Re: Design Exception #DE33-05 - Rood Avenue Parking Structure Parking  
Dimensions

## DESIGN EXCEPTION #DE 33-05

RE: Rood Ave. Parking Structure – Parking Dimensions

RE: Parking Module Dimensions for Proposed Rood Avenue Parking Structure

### ST. MARY'S PARKING STRUCTURE

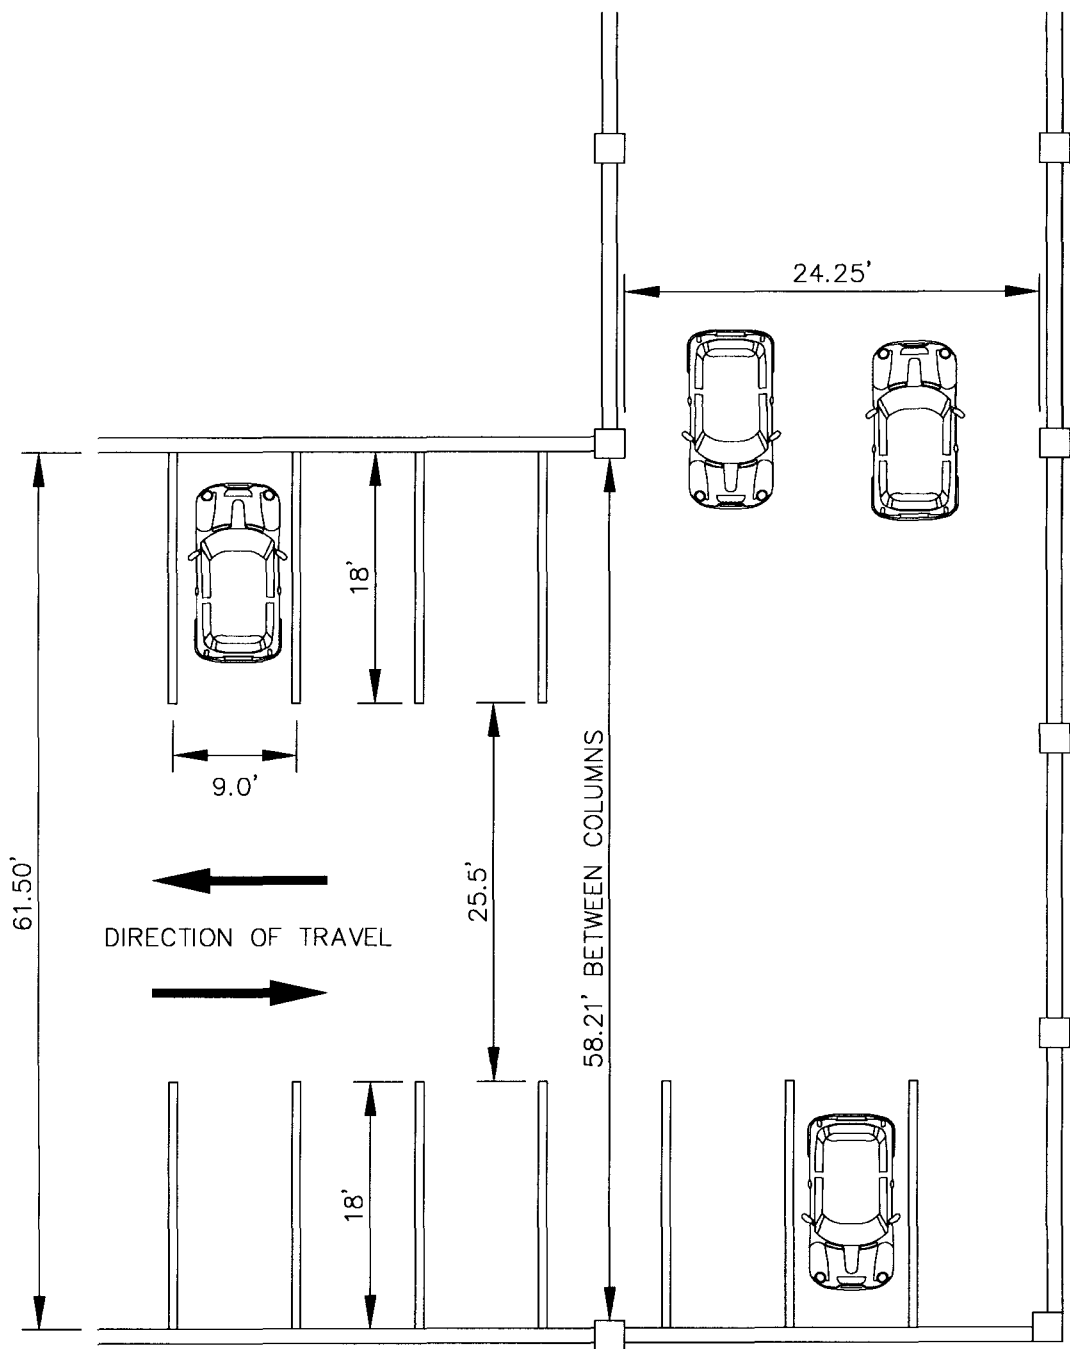
The City/County Parking Garage and St. Mary's Hospital parking modules dimensions don't meet TEDS Chapter 4. Field measurements of both modules were taken and are attached. The Rood Ave Parking Structure proposes parking module dimensions are more generous than either of the two existing parking structures.
